CHANGE ORDER NUMBER: 7

Project: 221FB39
Roadway: FM 1460 - SH 130
CSJ Number: _____

CR 111 Westinghouse Rd Williamson County Project No. 22IFB39 Change Order No. 7

Description: Existing Culvert 4 Wall Extension & 223 Rail Addition

ESTIMATE &
QUANTITIES

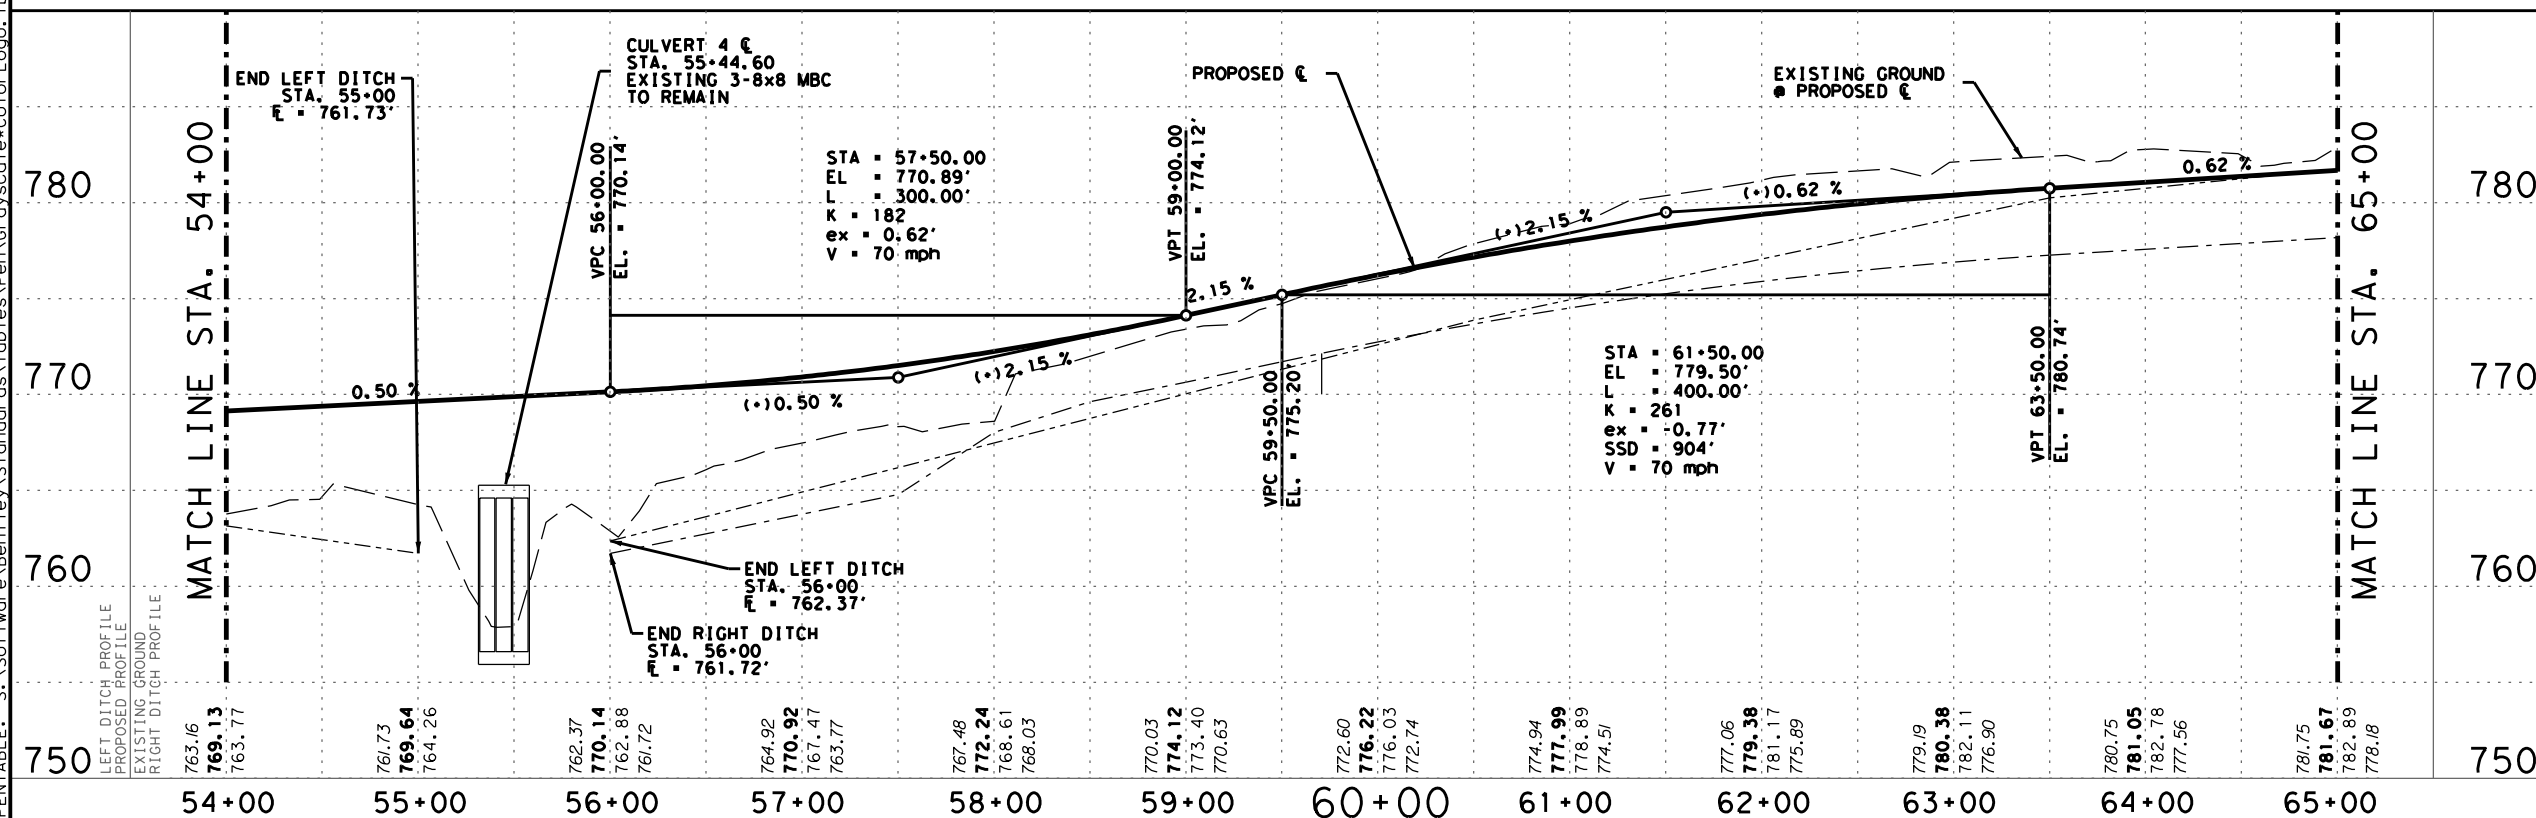
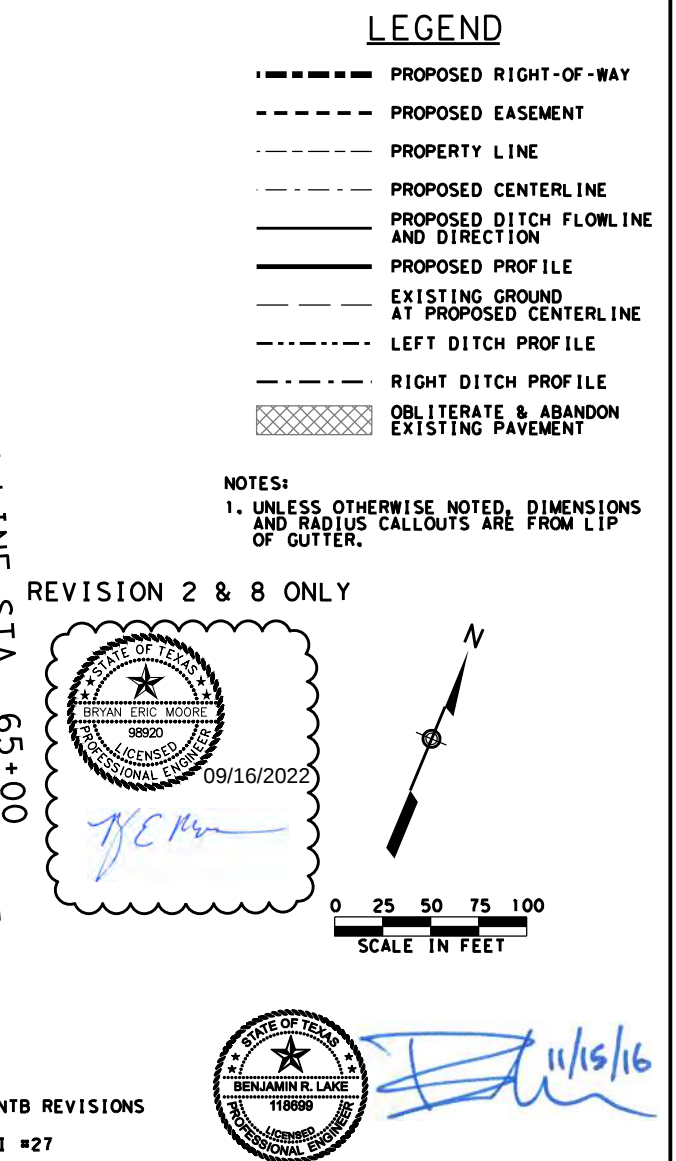
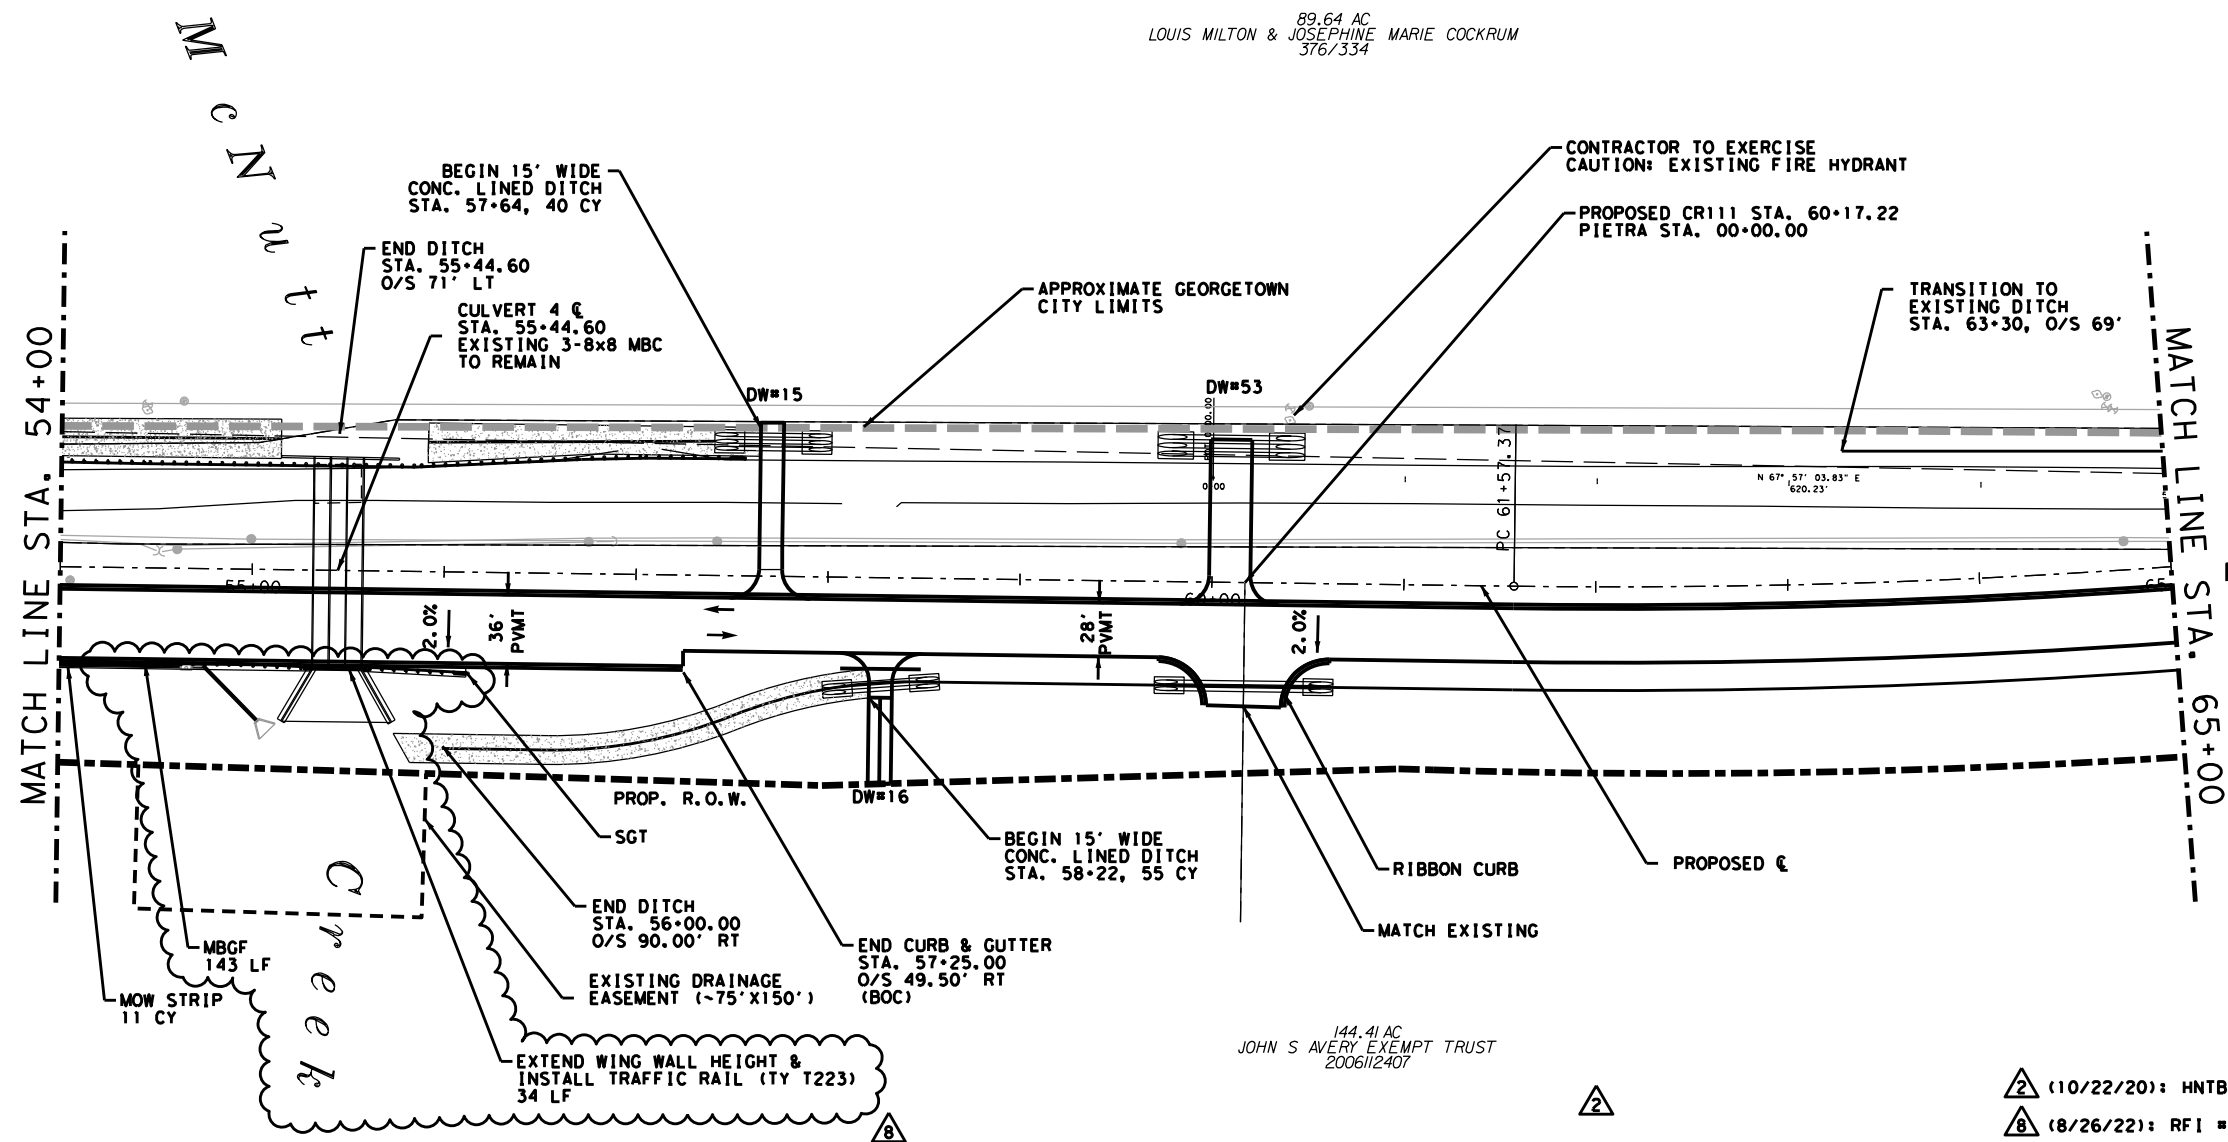
(08/26/22): RFI #27

FILE: r1std005-19.dgn	DN: TxDOT	CK: TxDOT	DW: JTR	CK: AES
©TxDOT September 2019	CONT	SECT	JOB	HIGHWAY
REVISIONS				
DIST	COUNTY			SHEET NO.
				113A

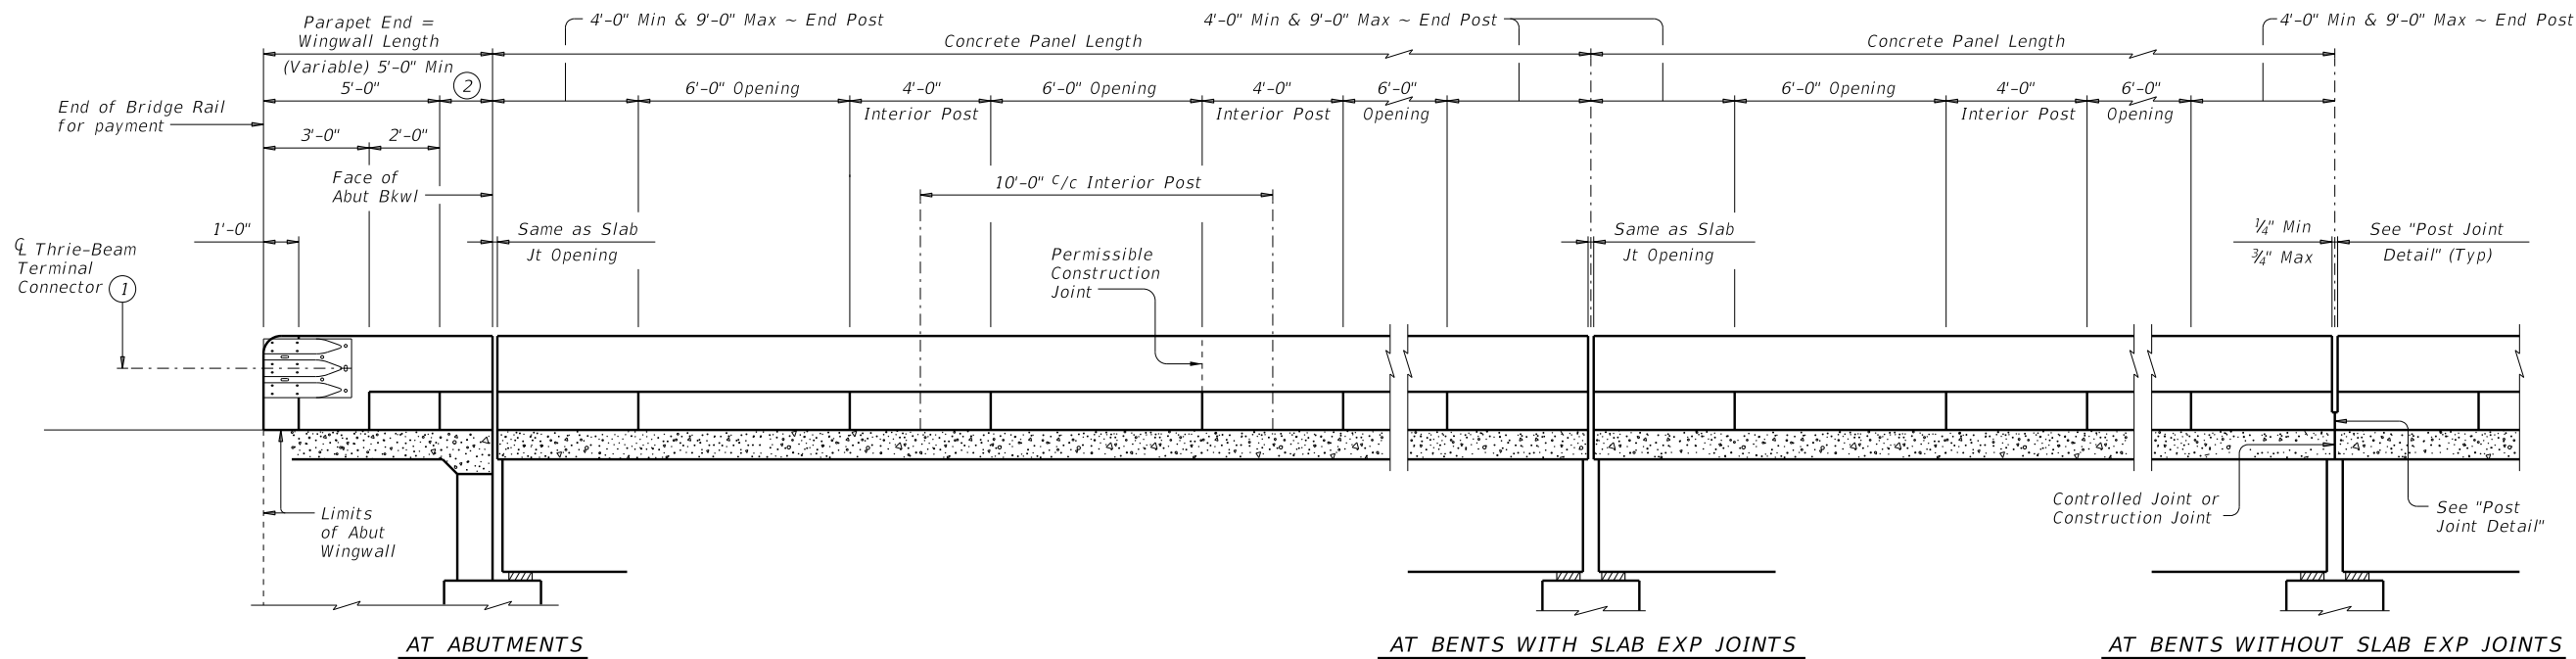
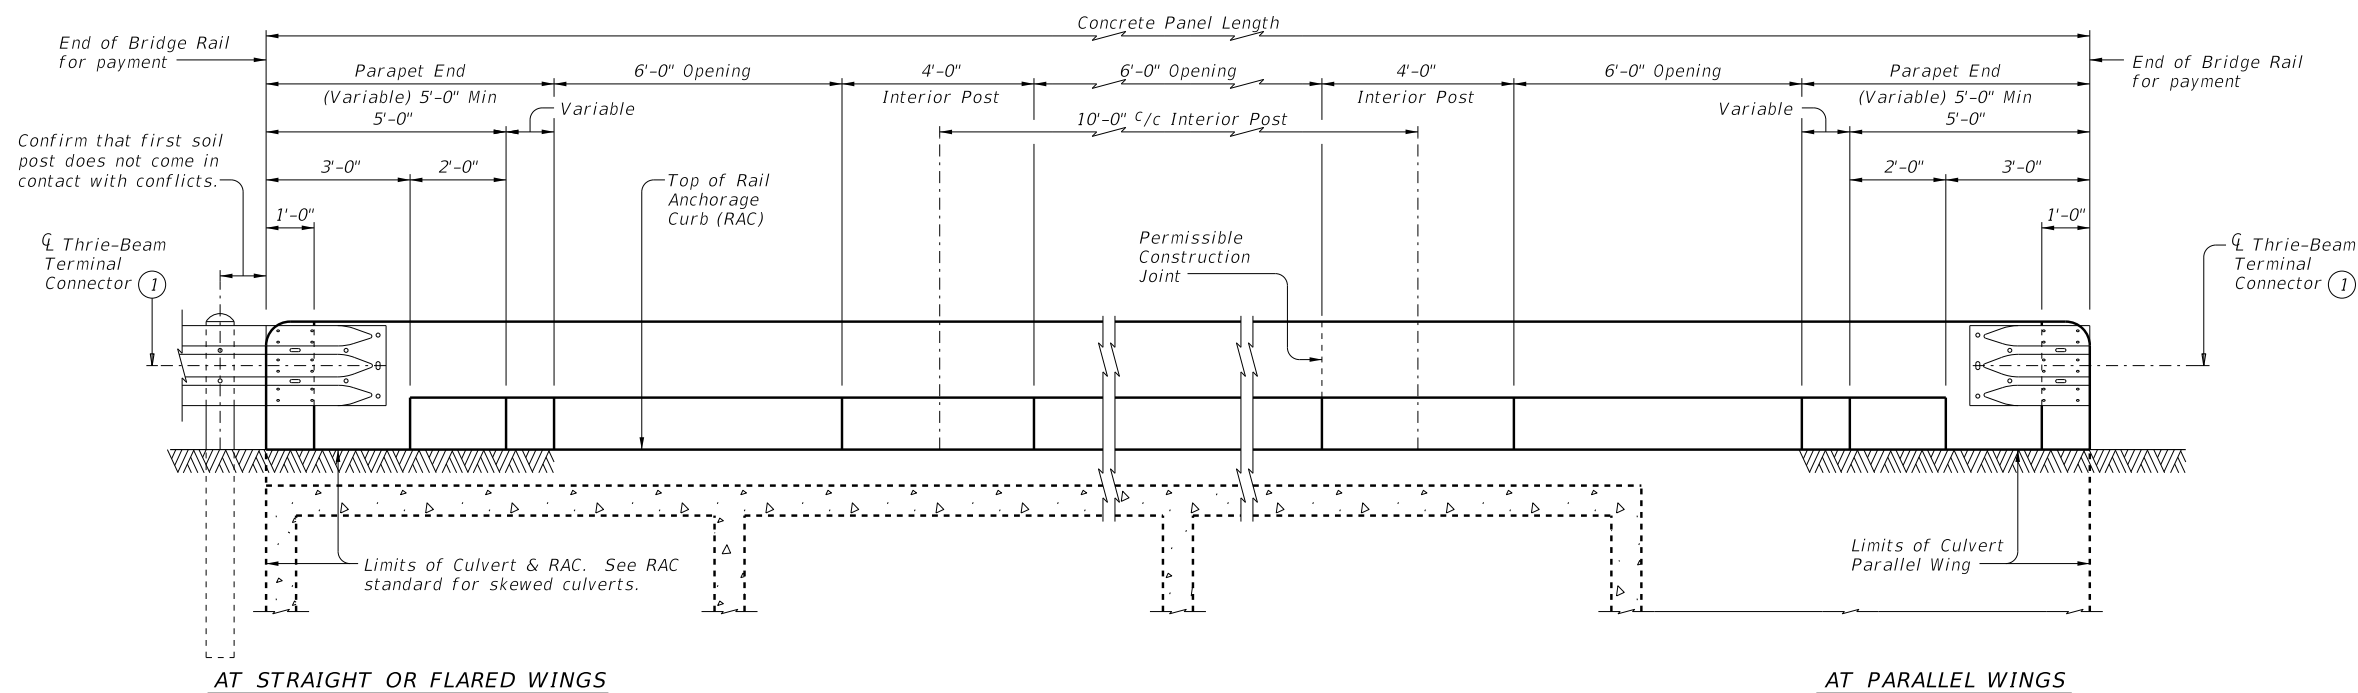
1B. Design Error or Omission. Other: This Change Order provides additional items to the Contract for adjusting an existing headwall, wingwalls and adding concrete rail along an existing culvert that is to remain in place. Due to the height of the existing culvert, the proposed roadway can not be built to the proposed width. Raising the headwall and constructing the rail will allow for the roadway portion to be constructed to the proposed width. This rail will mirror the existing rail along the upstream portion of the existing culvert.

This Change Order provides payment to the Contractor for additional work needed to adjust an existing headwall and wingwalls to allow for the roadway to be constructed to the proposed plan width. The existing Culvert 4 is to remain in place, but due to the location of the existing headwall it will not allow for the roadway to be built to plan width as there is no support for the roadway section at the culvert. RFI 27 addresses the issue and provides additional plan sheets to extend the headwall, wingwalls and adds traffic rail so that the roadway portion can be constructed to the proposed width.

We revised the design to be in line with the recommended solution provided by HNTB; extend the existing headwall and wingwall height and install a concrete traffic rail. Sheets showing the plan revisions, standard details, and updated quantities are attached.
